PROJECT NAME: STERLING HALL SCHOOL – PHASE 1 MASTER PLAN ADDITION

PROJECT No.: 00036-010-E-001

DATE: 2026-07-22

ADDENDUM No.: E01

scale: 1 : 75  
date: XX/XX/2X  
drawn: RLJG  
checked by: Checker  
project number: 00036.010.E001  
drawing number: E-403  
Revision: 7

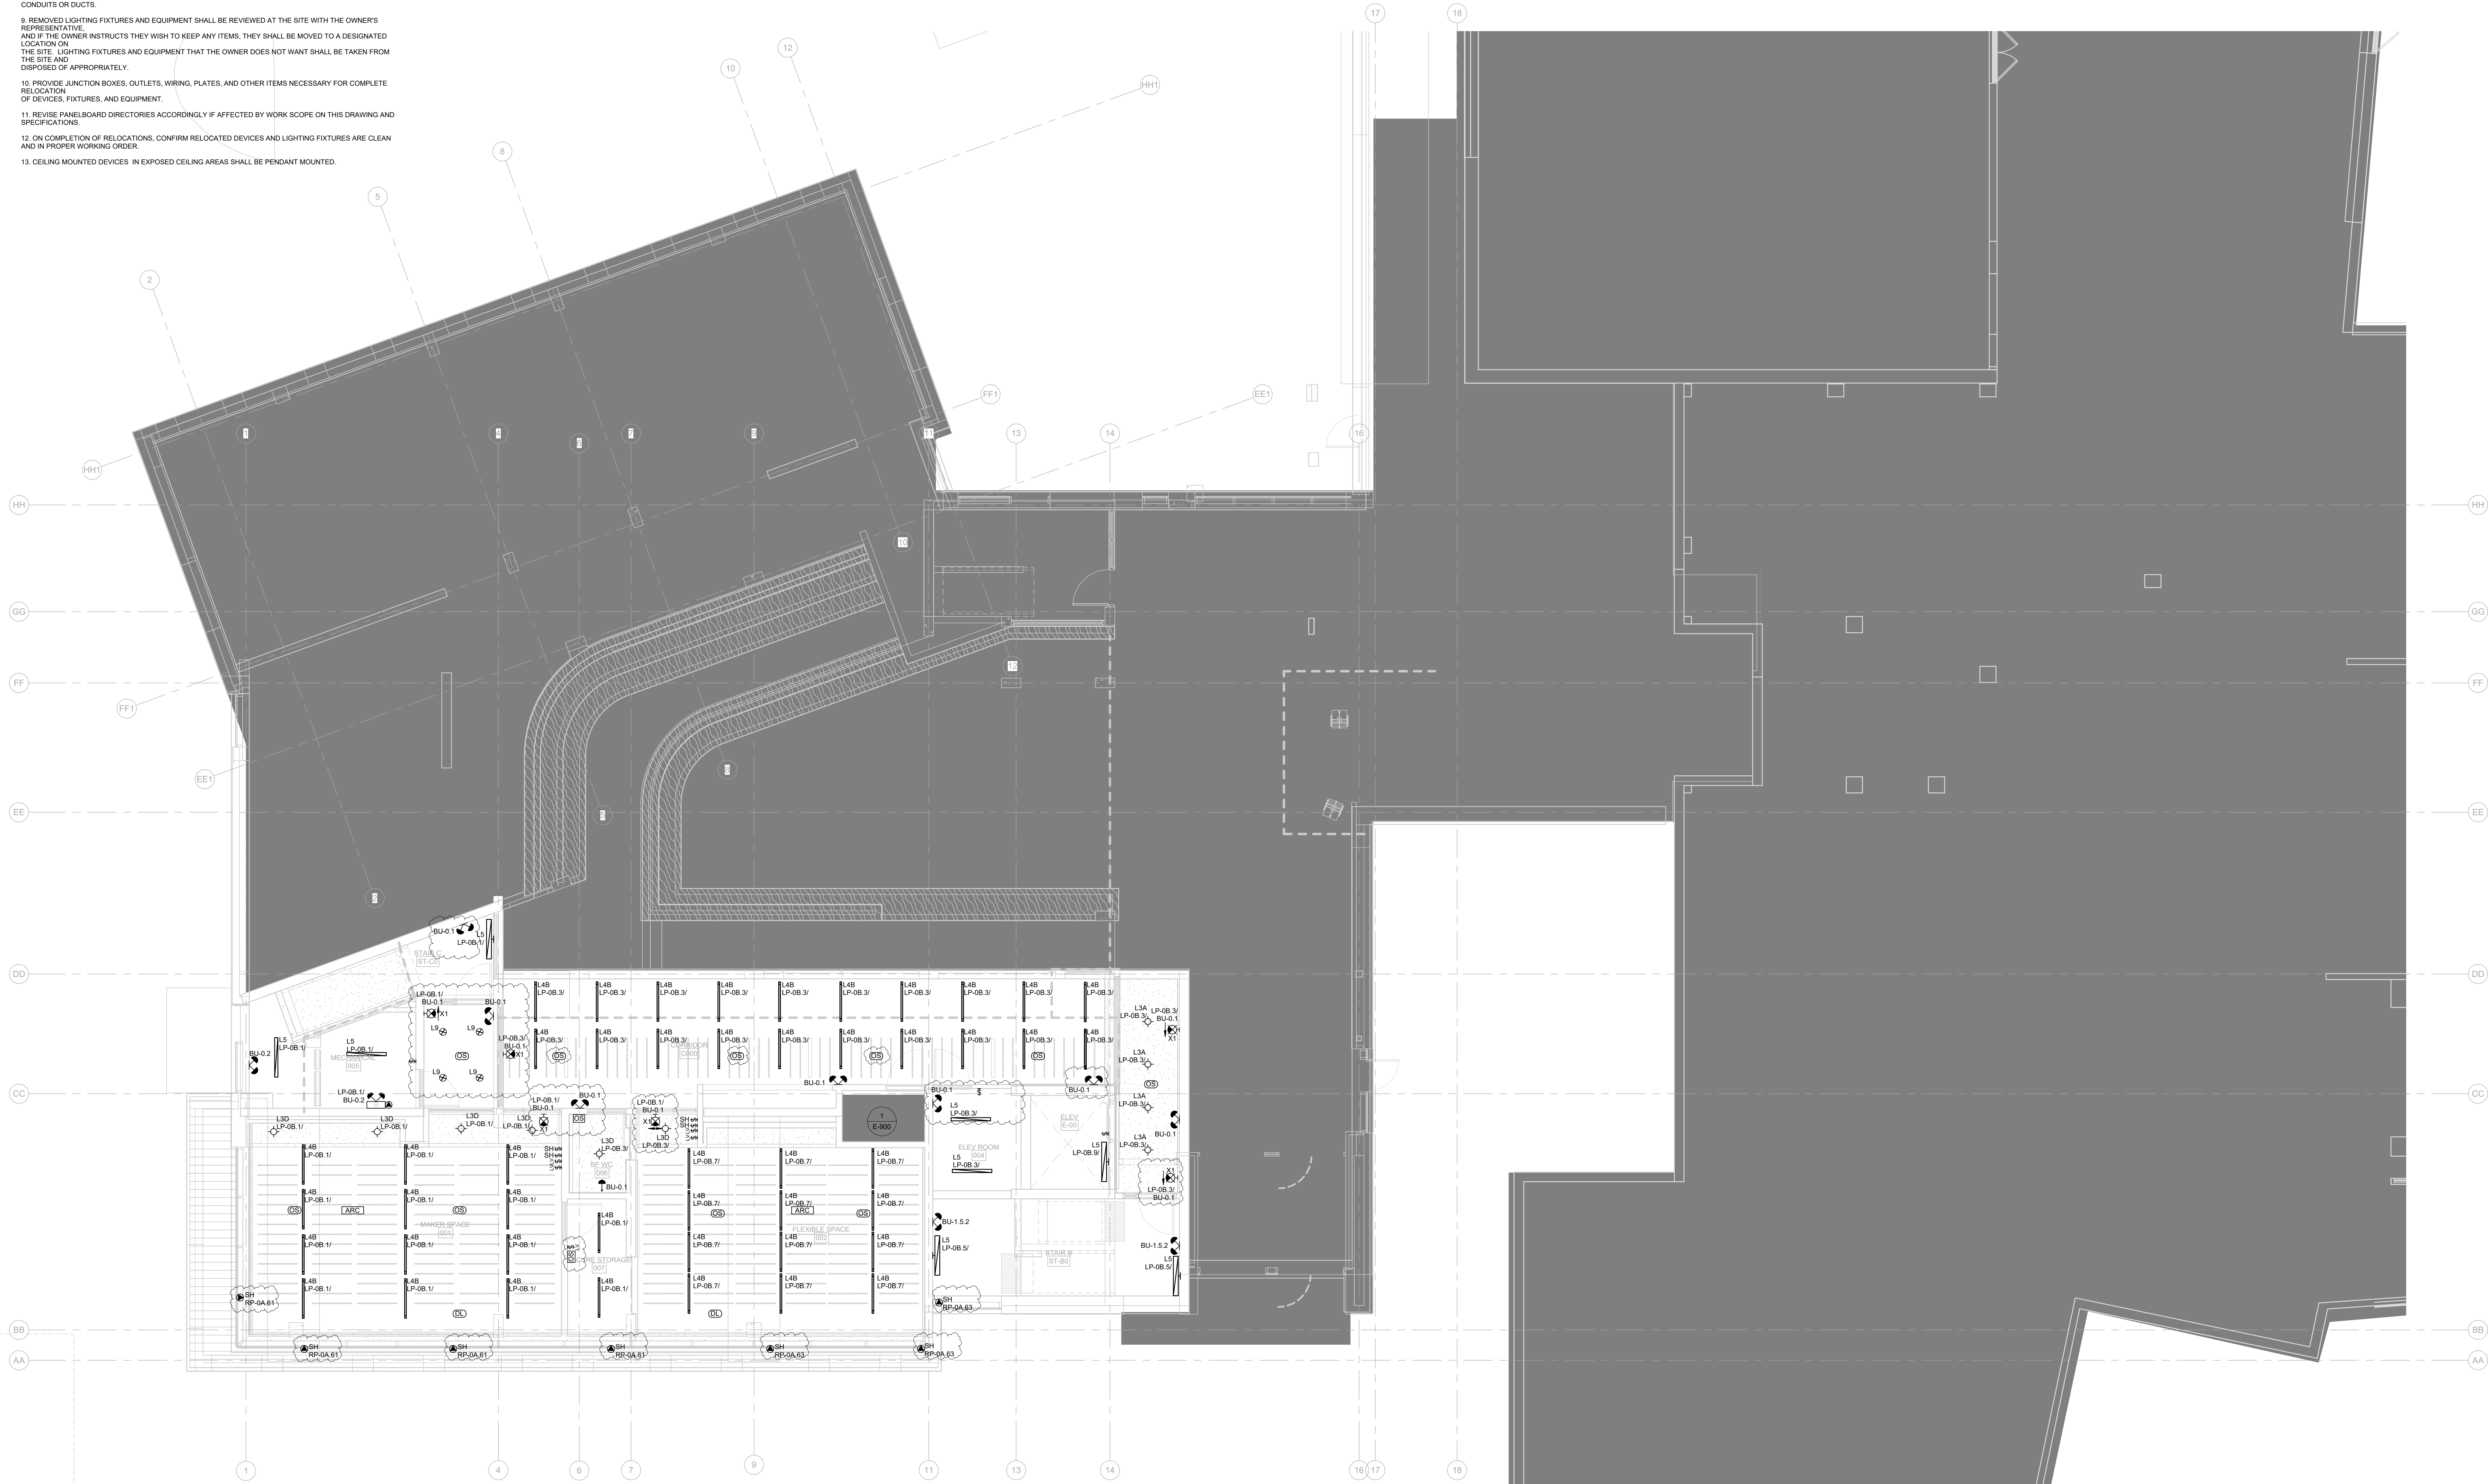
- 2.1.12 E-402: Revise power and communication layouts. Add electrical and data outlets and circuits.
- 2.1.13 E-403: Revise power layouts. Add electrical circuits and outline of future solar panel.

scale: 1 : 75  
date: XX/XX/2X  
drawn: RLJG  
checked by: Checker  
project number: 00036.010.E001  
drawing number: E-501  
Revision: 8

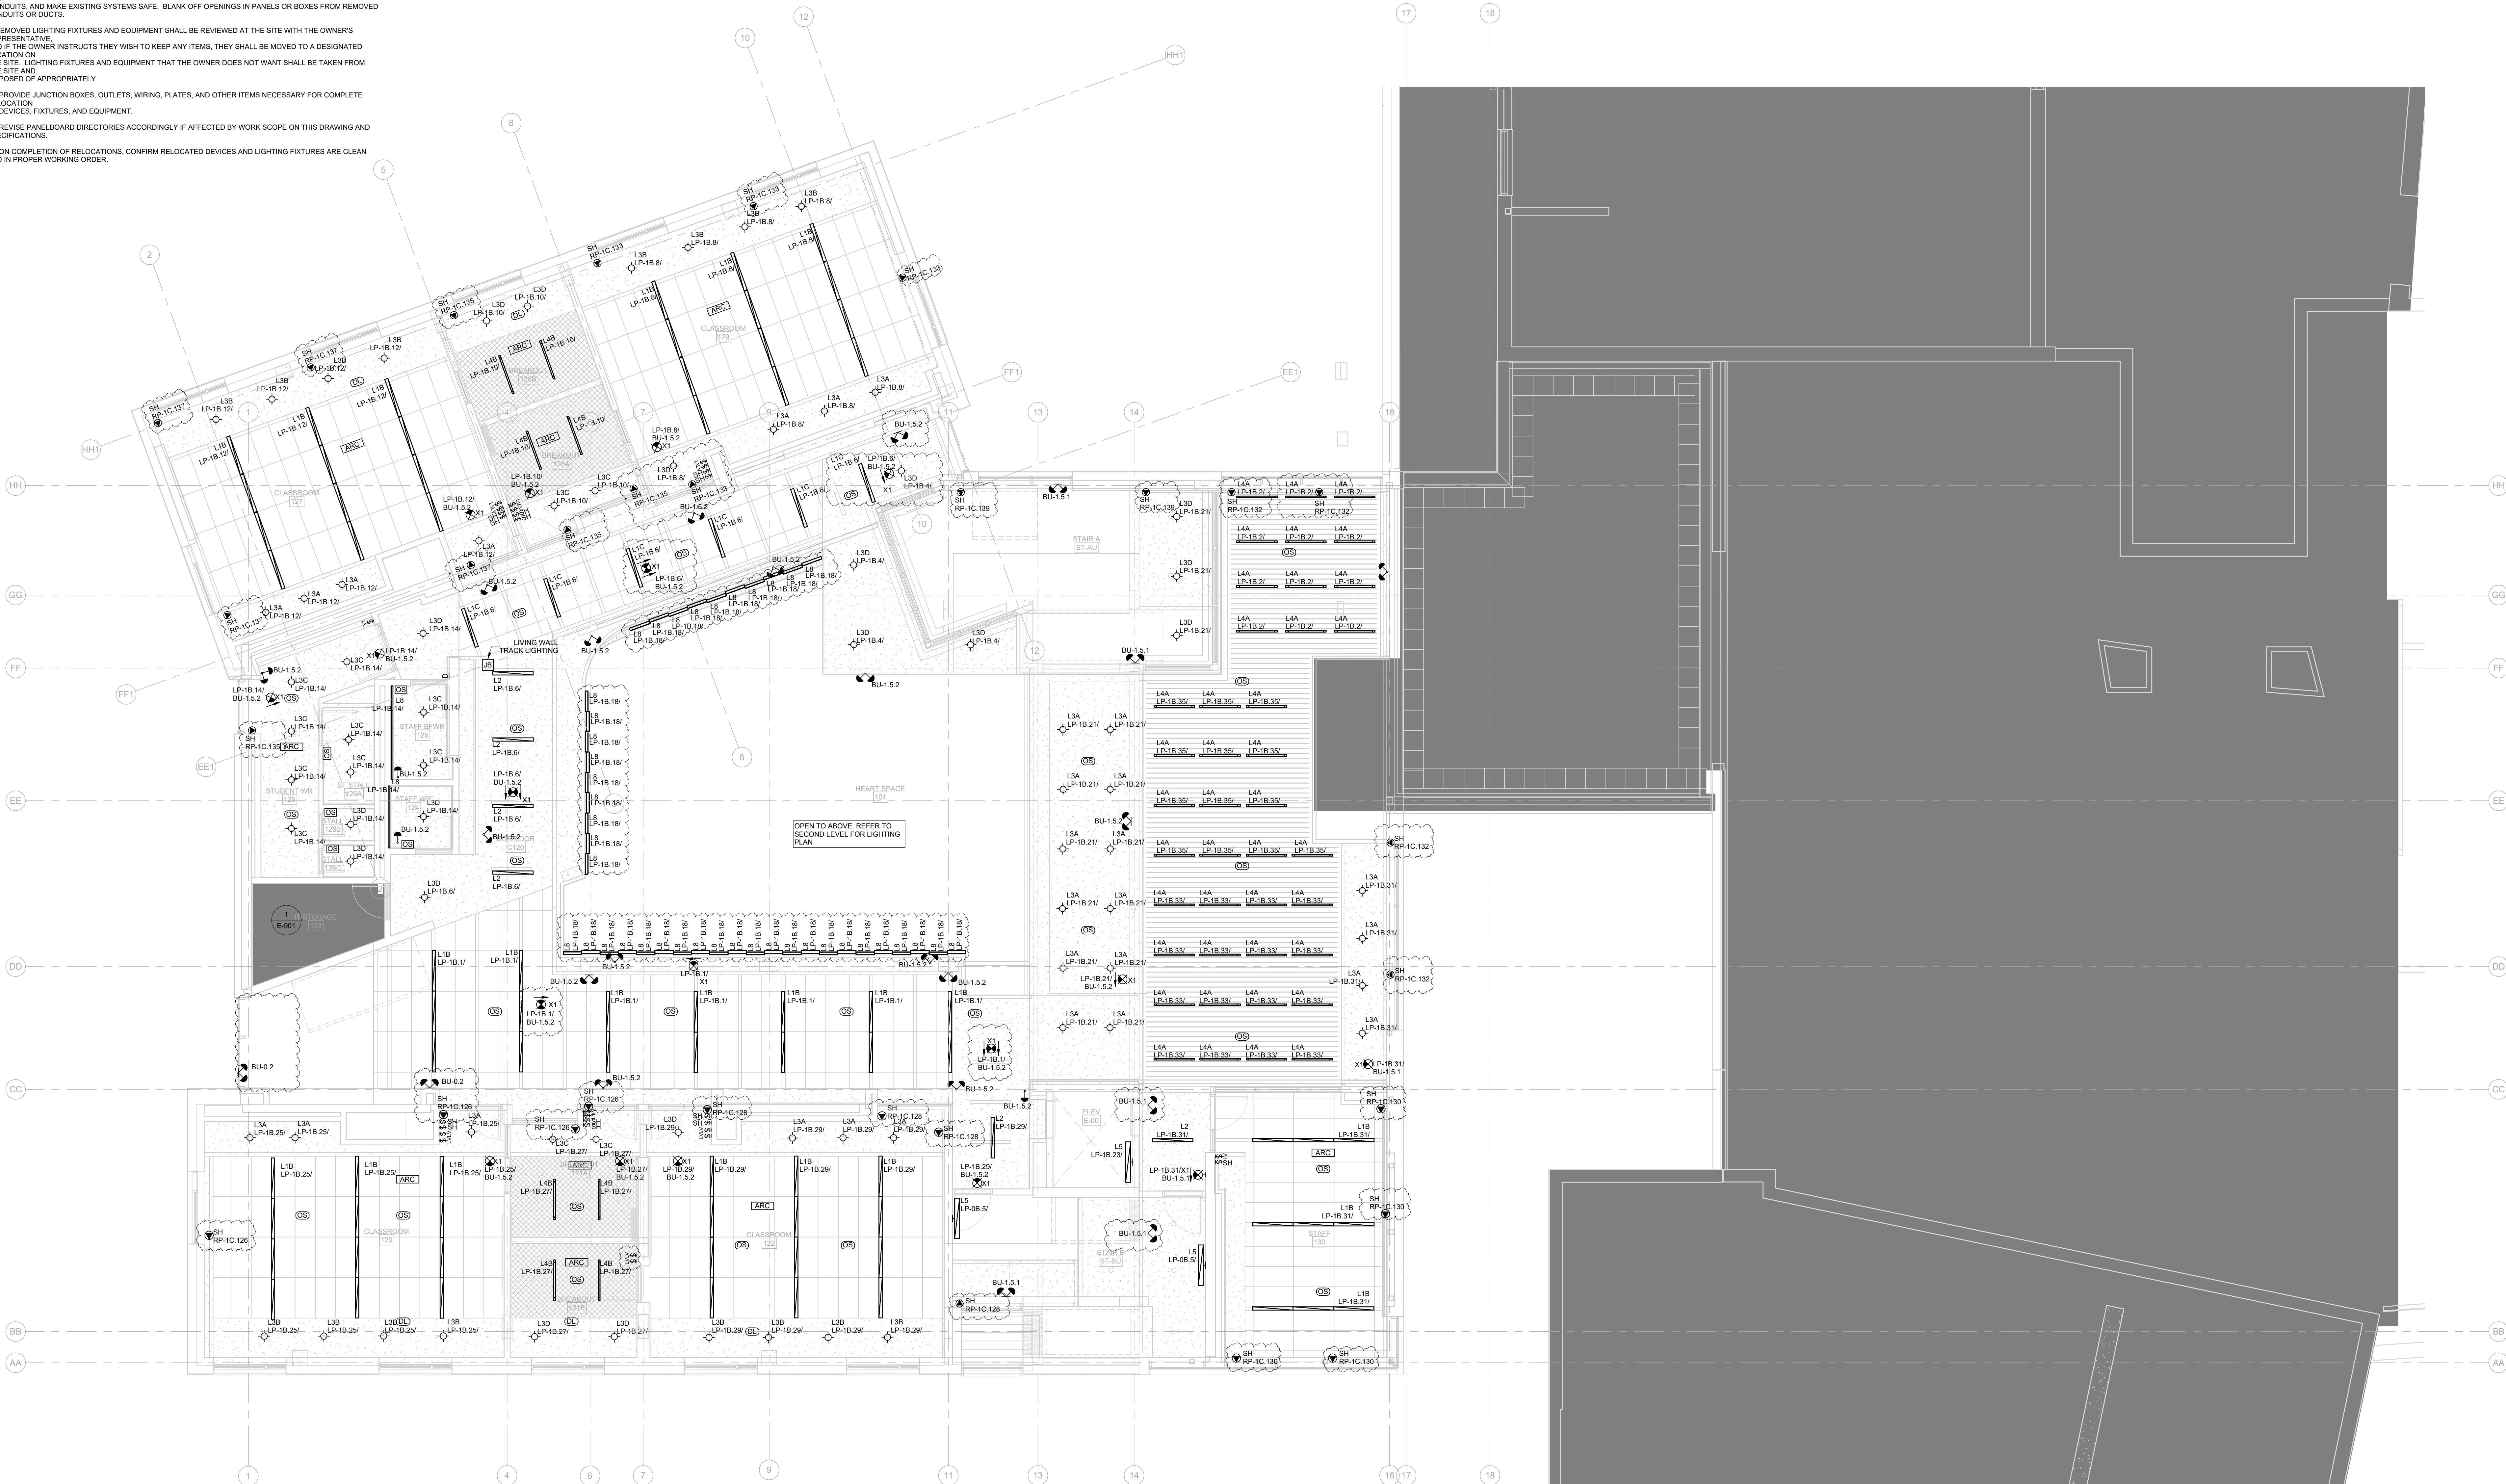
- 2.1.14 E-500: Revise lighting layout, emergency lighting and exit signs. Add circuits.
- 2.1.15 E-501: Revise lighting layout, emergency lighting and exit signs. Add circuits.

scale: 1 : 75  
date: XX/XX/2X  
drawn: RLJG  
checked by: Checker  
project number: 00036.010.E001  
drawing number: E-602  
Revision: 8

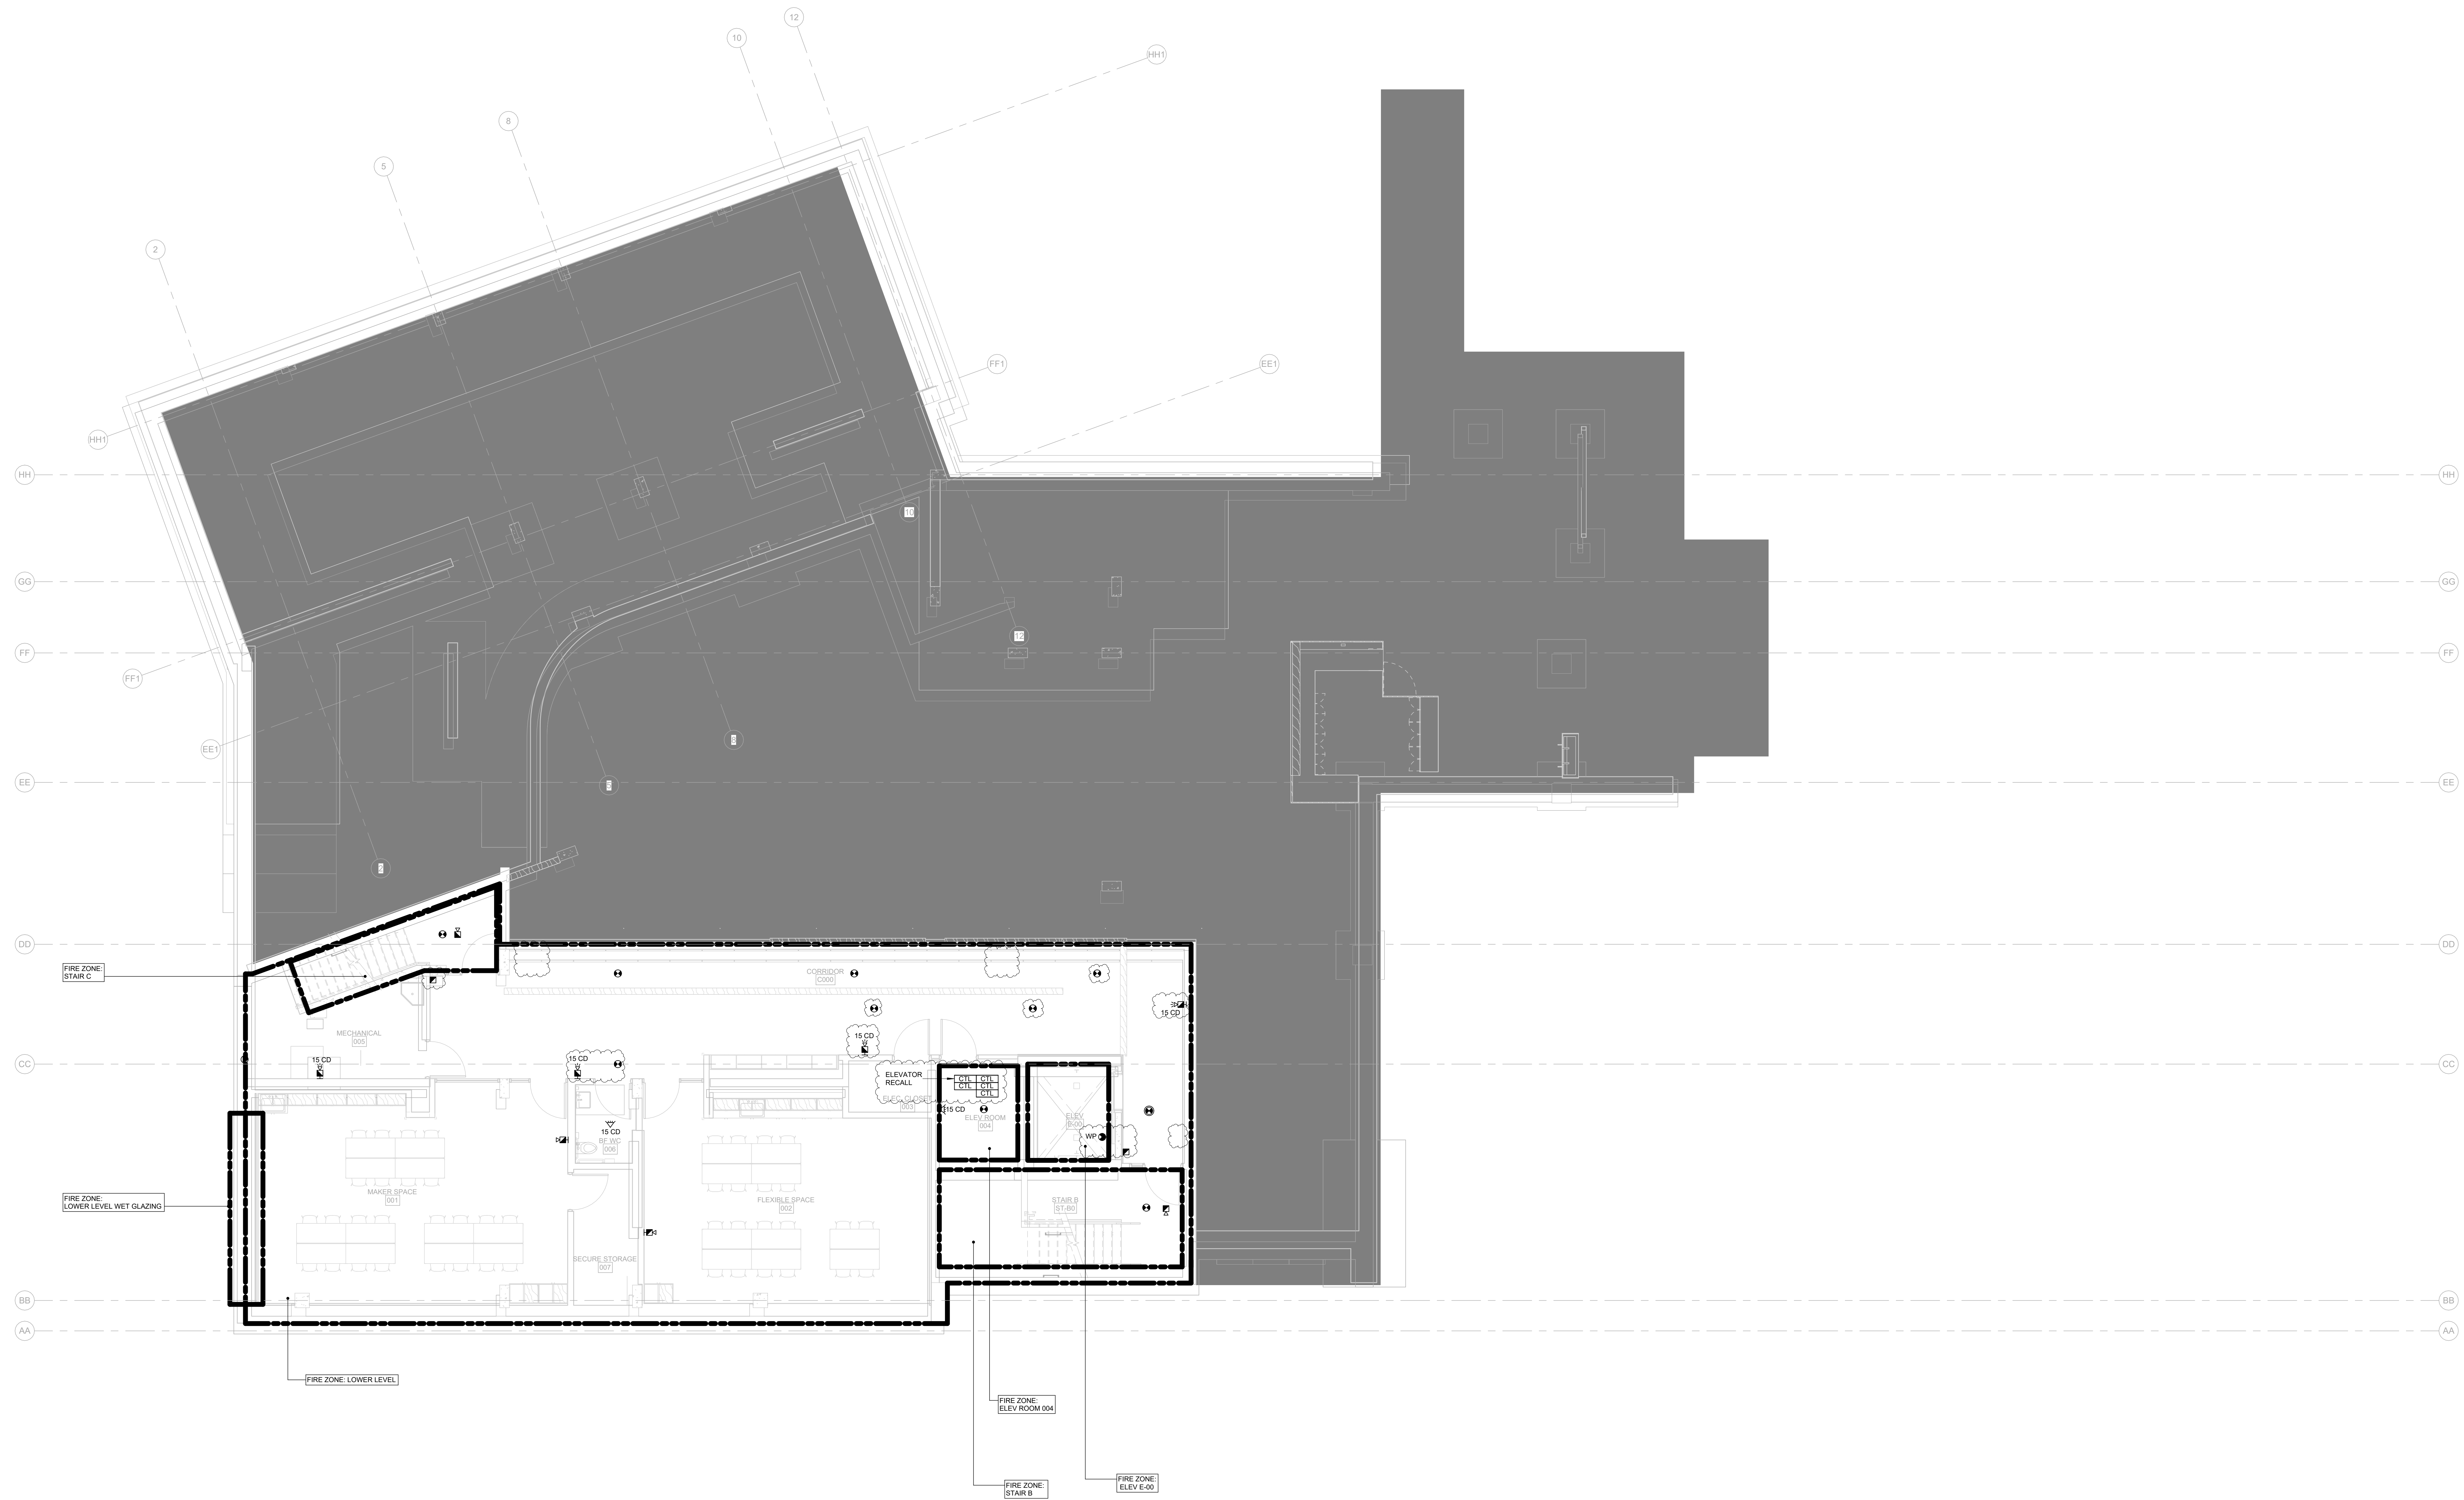
- 2.1.18 E-601: Relocate security devices.
- 2.1.19 E-601.5: Relocate security devices.
- 2.1.20 E-602: Relocate security devices.
- 2.1.21 E-700: Revise fire alarm device layout. Add fire alarm control modules.
